## **Access Compliance Report Public Rights-of-Way** (Curb Ramps)

Intersection ID: 27355 Main Street: JOHNSTON RD **Cross Street: BRIXHAM AV** Location: NW **Overall Compliance: No ADA ID: 0098E61B7CEA** Ramp Type: Perp Initial Pass/Fail: Fail Severity Score: 26.25

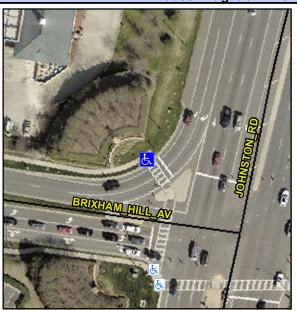
Ramp Slope (%)

47.0

Possible Solutions:	Compl	iance	Description
Remove & Replace Entire Ramp.	N/A	Ram	p Length (in)
·	Yes	Ram	p Width (in)
	N/A	Flare	Type LT
	N/A	Flare	Slope LT (%)
	N/A	Flare	Traversable L
	N/A	Land	ing Length (in)
Surveyor Notes:	N/A	Land	ing Width (in)
N/A	N/A	Land	ing Slope (%)
	N/A	Land	ing X Slope (%
	N/A	Land	ing Curb? (Y/N
	N/A	Shar	ed Landing?
PROW/ADA:	N/A	Gutte	er Ponding?
Not Found, R304.2.2, R304.5.3	N/A	Gutte	er Lip Ht (in)
	N/A	Paint	ed X Walk1?
		X Wa	alk 1 Direction
	N/A	X Wa	alk 1 Width (in)
		X Wa	alk 1 Slope (%)
		X Wa	alk 1 X Slope (%
	N/A	Ram	p inside XWalk′
		Poor	Slone (%)
